Staff Technical Position on Geological Repository Operations Area Underground Facility Design -- Thermal Loads

U.S. Nuclear Regulatory Commission

Note: Throughout this comment response package, "STP" refers to the staff technical position noticed in the *Federal Register* on July 22, 1991 (NRC, 1991; 56 FR 33478).

Figure 1. The Logic Flow of an Acceptable Methodology for Demonstrating Compliance with 10 CFR 60.133(i).

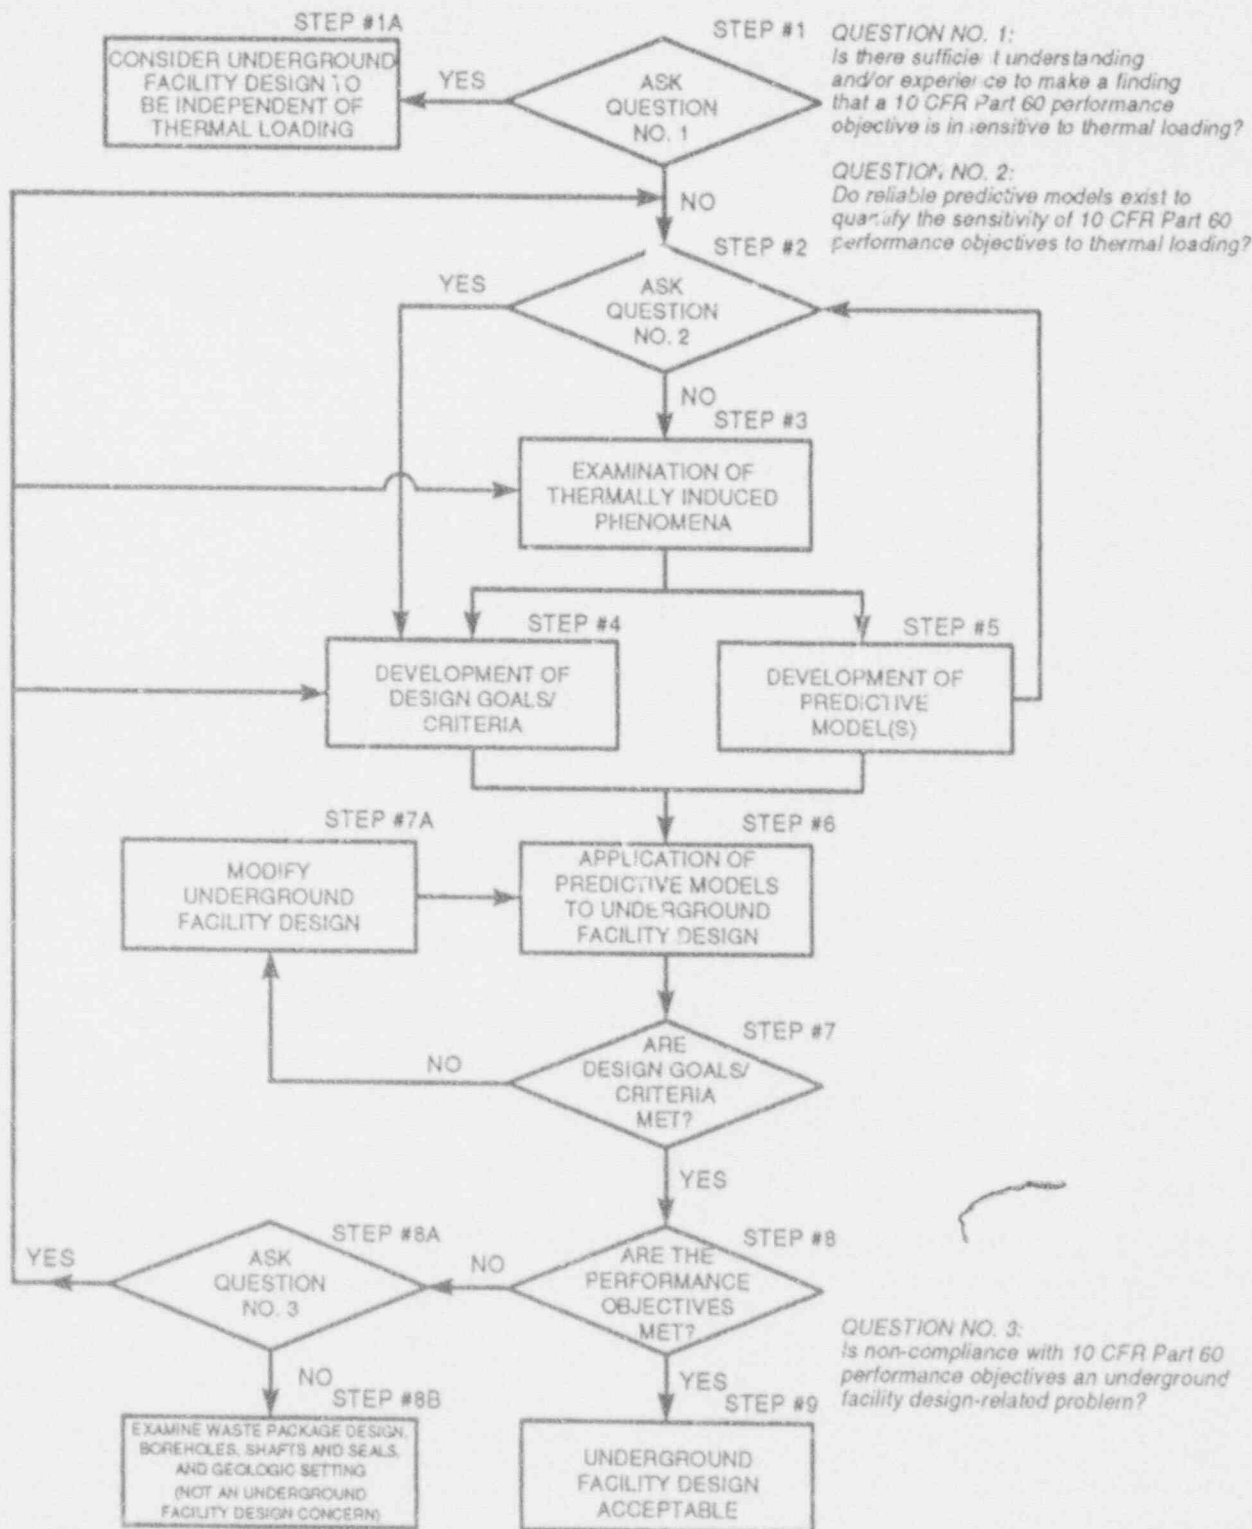
The STP is too generic and lacks pertinent details to meet its stated purpose. The acceptable methodology for demonstrating compliance with 10 CFR 60.133(i), as described on pages 7-10, is incomplete and lacks some crucial details of acceptable method for decision making, especially in the case where the available information will reflect large uncertainty at the programmatic and technical decision points shown in Figure 1.

This comment is noted. However, the staff believes that the Department's recommendation would lead to an internal inconsistency that violates the overall logic detailed in Technical Position 3.1 and depicted in Figure 1. The staff's reasoning behind this position is that if there is an affirmative response to the question asked in Step No. 2, then the need to perform the analyses described in Step Nos. 3 and 5 would be obviated because existing models would already have these capabilities.

Step No. 3 needs to be clarified since it is not apparent if "defensible models" used in Step No. 3 are in fact those "existing models" that will show compliance with 10 CFR 60.133(i), as illustrated in Step No. 2A, Figure 1.

Other than the first step, Figure 1 does not indicate decision points at which the process may be terminated. Either add these decision points or do not say that they are present.

28. Page 25, Figure 1

The staff agrees with the State of Nevada comment regarding the need to revisit Step No. 2, and has modified the recommended approach accordingly. The modification involves a return from Step No. 5 to Step No. 2 in Figure 1. In addition the text for Step No. 5 has been changed in Technical Position 3.1.

However, DOE's recommendation has caused the staff to re-evaluate the logic depicted in Figure 1 and in an attempt to clarify this logic, the staff has modified the figure in the final version of the STP in two ways. First, Step No. 2A ("Use existing models to show compliance with 10 CFR 60.133(i)") in the draft version of the STP was deleted because there is no activity associated with this step *per se*. Second, the logic flow from Step No. 5 to Step No. 3 in the draft version of the STP has been changed to now indicate an iteration between Step Nos. 5 and 2. The change was made so that the approach includes an explicit check of the adequacy of any predictive models developed with existing technology.

the entire process is iterative (see the loop-back from Step No. 8 to Step No. 3 in Figure 1).

The staff agrees that the flow logic shown in Figure 1 for Technical Position 3.1 does not indicate any decision points for termination of the process other than the first step. Consequently, the 5th paragraph of Section 4.1

Regarding the first portion of this comment, DOE is referred to the last paragraph of Step No. 8, under Section 4.1 ("Discussion"), where a discussion is provided of what takes place beyond Step No. 8B. Accordingly, the staff believes that the logic flow after Step No. 8B in Figure 1 is closed.

Figure C2. Example of an Iterative Process for the Analysis of Thermally-Induced Phenomena.

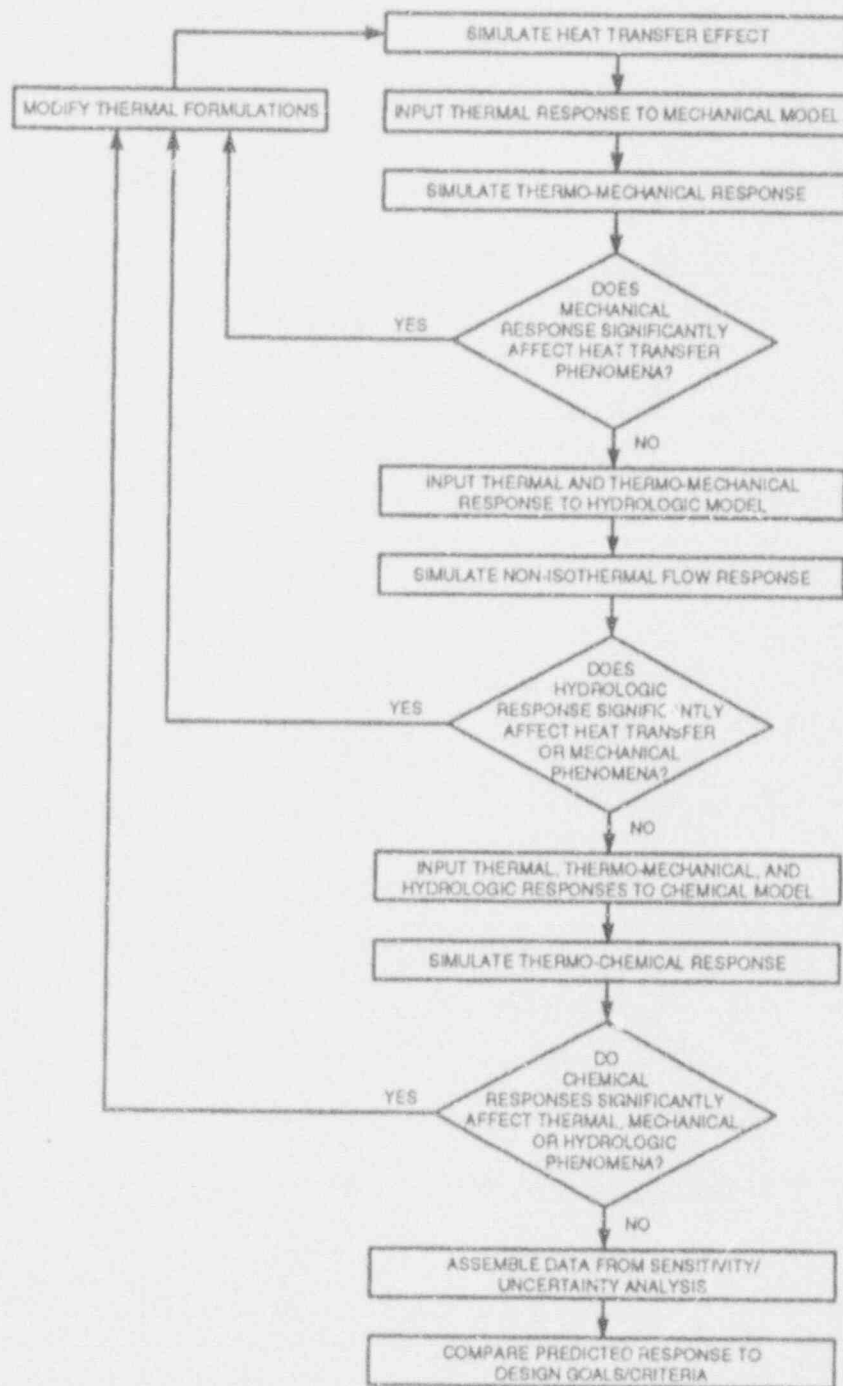
The STP states: The order in which the phenomena (e.g., thermal, mechanical, hydrological, or chemical) are analyzed in Figure C1 is shown only as an example. The responsibility to determine the most appropriate sequence of analyses rests with the licensee."
